Landmarks Board

LANDMARKS BOARD STAFF REPORT

CASE: Certificate of Appropriateness

LOCATION: 504 East Commercial Street

ROOF TOP PATIO PLAN

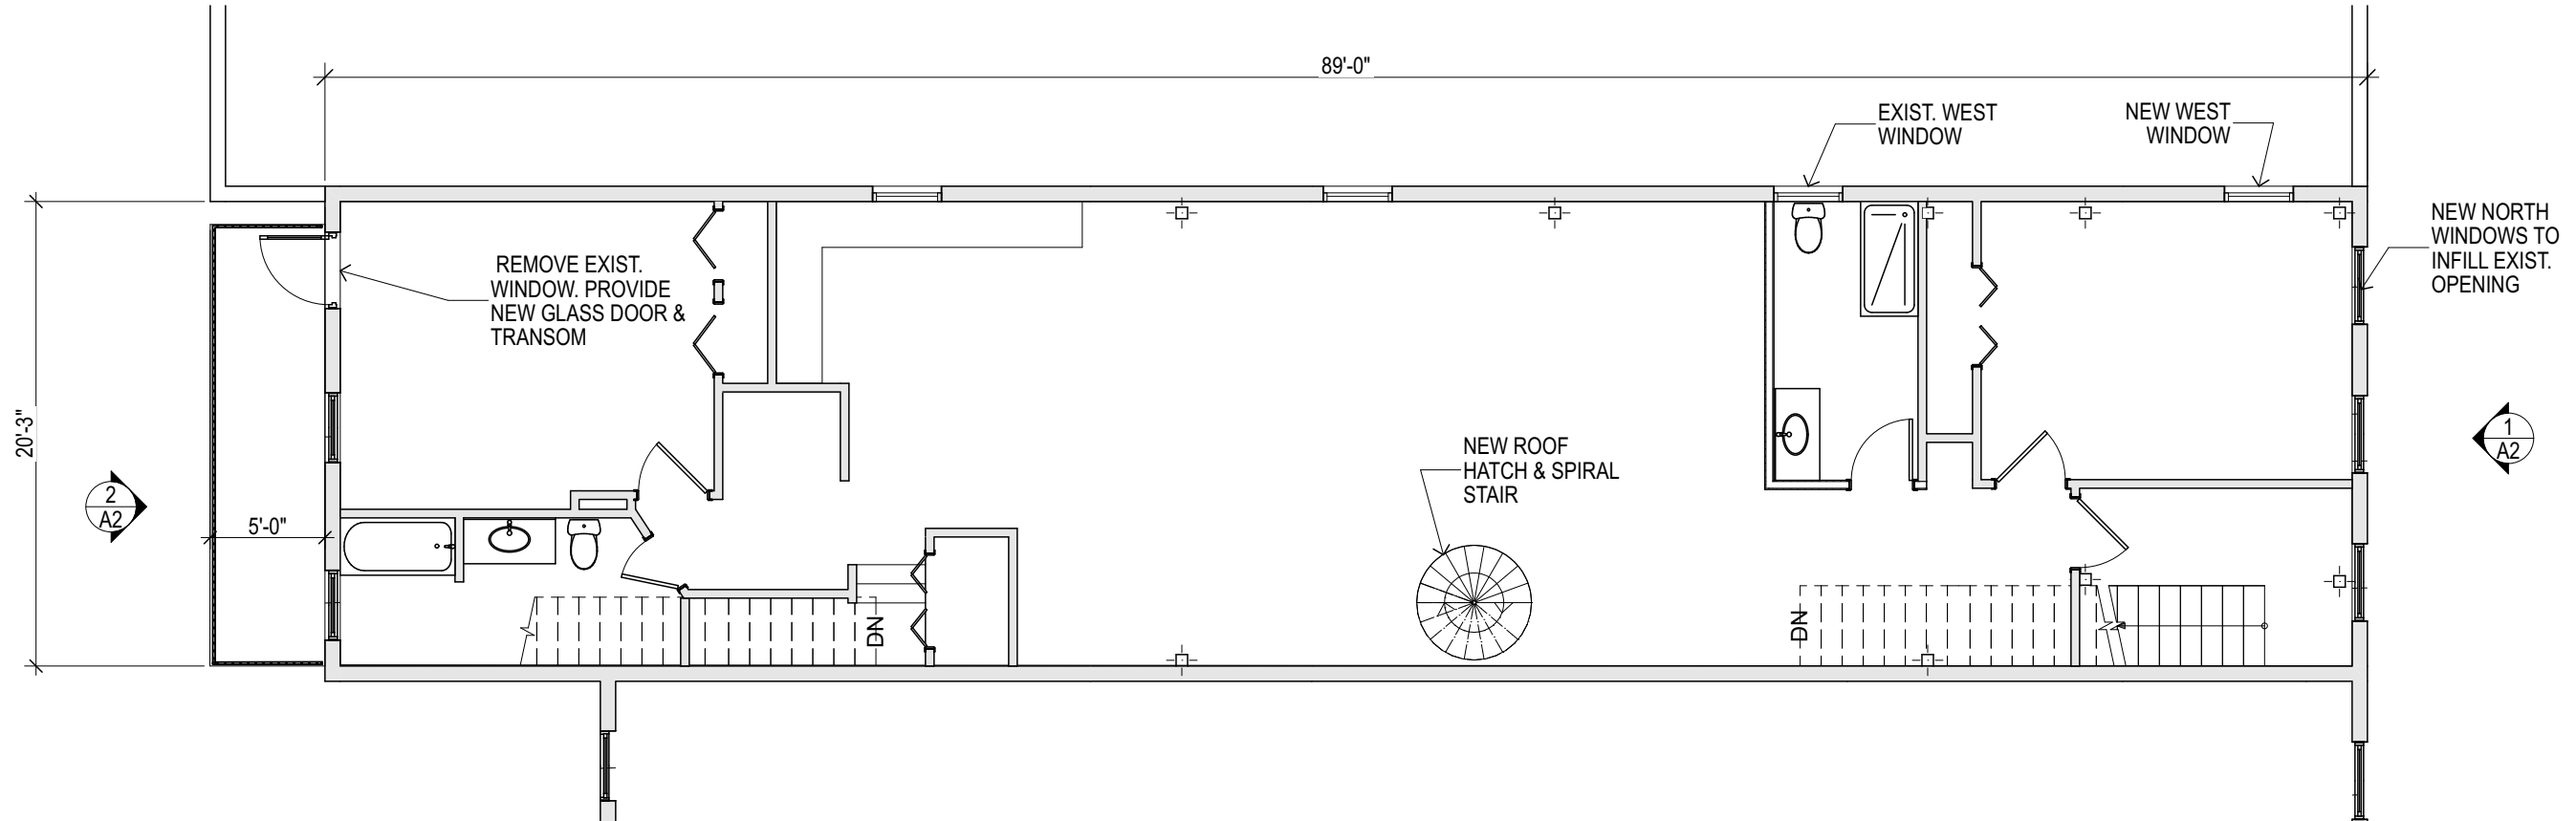
3. Regarding the rooftop patio and railing:
 - a) Rooftop patios and railings are not specifically addressed in the Commercial Street Design Guidelines. However, a common recommendation in the guidelines is to respect the existing scale, massing and arrangement of the building's elements and that the new elements do not obscure the original buildings portions or elements. The railing appears to be located below the building's front parapet wall. However, the railing appears to be visible along the sides on the building and at the rear. The front façade is considered the primary or most visually important façade. The Board would need to determine whether the rooftop patio and railing, if granted, will have a detrimental effect upon the Historic Landmarks or Historic District or any adverse effect on an historical or architectural resource.

WEST SECTION/ELEVATION

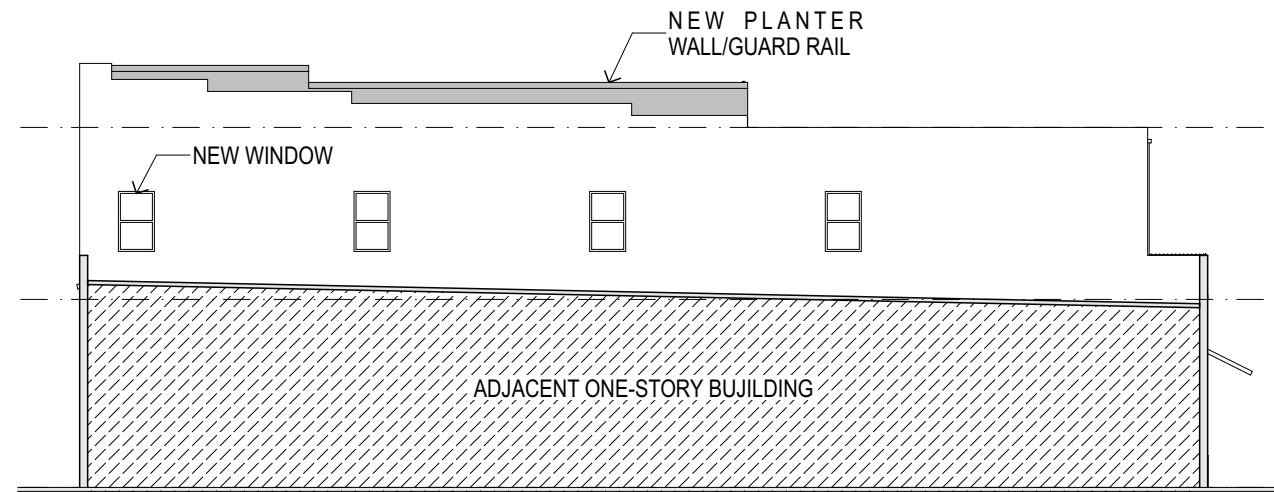
4. The addition of a new second-story window on the west elevation appears to be consistent with the existing spacing and size with the other three windows along the west elevation.

SOUTH ELEVATION

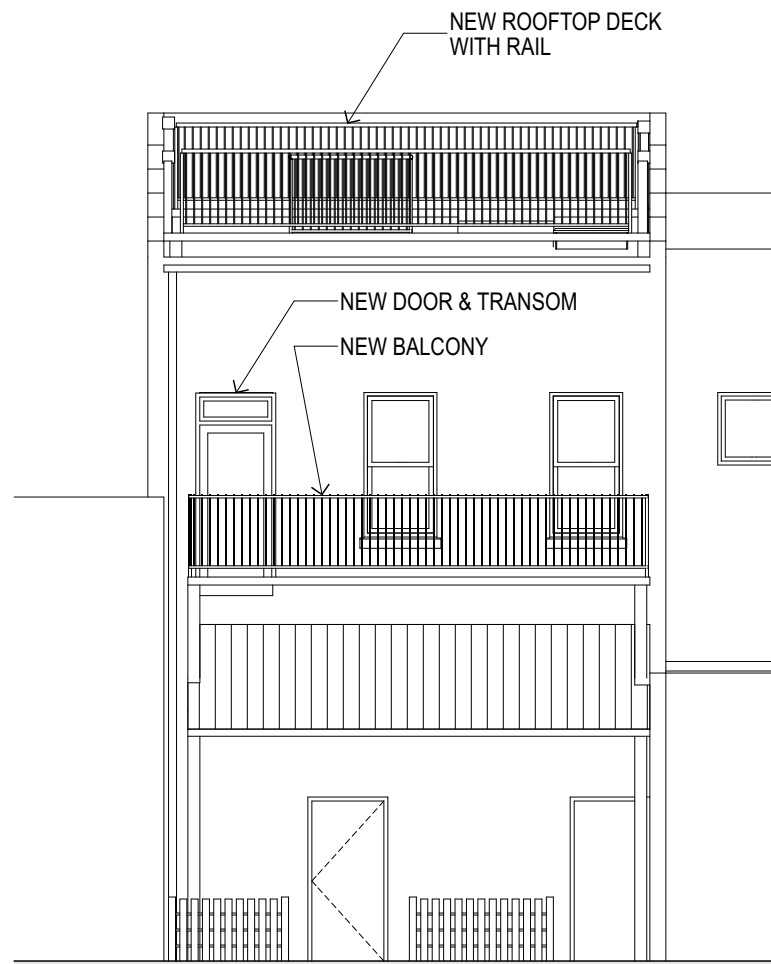
2. Regarding the rear elevation window removal with door and transom and steel framed balcony:
 - a) The proposed door opening appears to match the top and sides of the existing window opening while the bottom appears to be enlarged for the height of the door. The guidelines do not prohibit creating a rear entrance. Staff believes the rear elevation alteration are consistent with these recommendations. These alterations cannot be seen from Commercial Street, the primary face of the building. however it recommends that the rear entrance not visually exceed the front in importance or emphasis.

- b) The design guidelines recommend locating decks (balconies) on the rear façade and not visible from the primary façade. The guidelines also recommend to keep exterior decks simple in design and in proportion to the building and neighboring buildings. Decks may be constructed with structural steel with wooden decking and metal railings. The proposed deck appears to be consistent with these recommendations.

NORTH ELEVATION

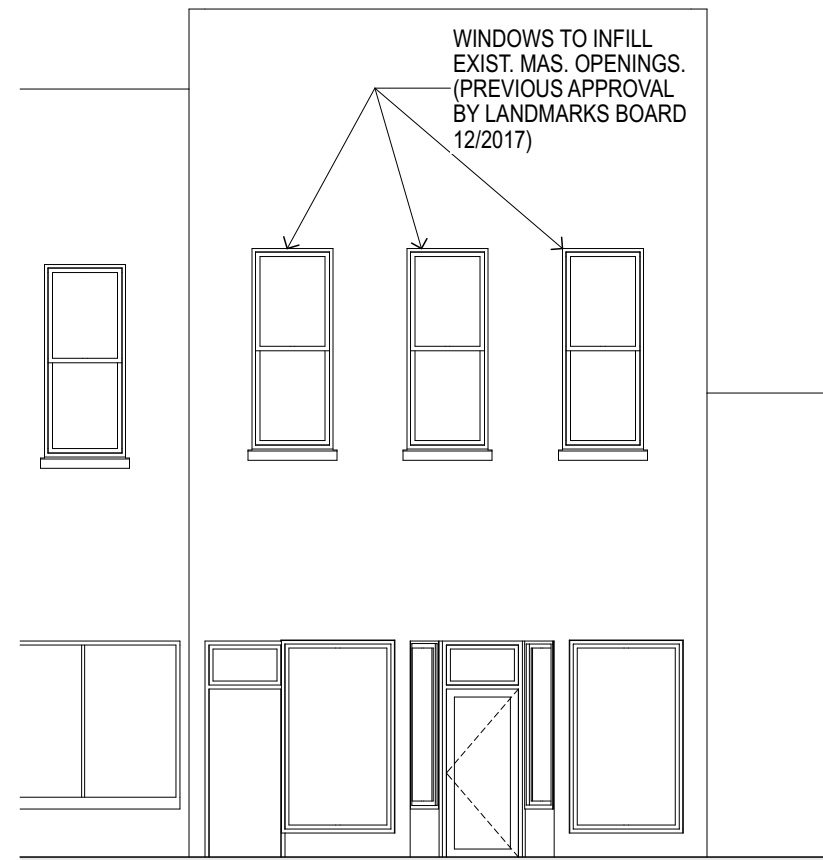
1. The removal of brick infill and replacement of three windows on second-story on front (north) elevation was approved by the Landmarks Board on December 13, 2017. That application was for all wood windows. This application is for aluminum clad wooden window. This alteration is consistent with the Commercial Street Design Guidelines.
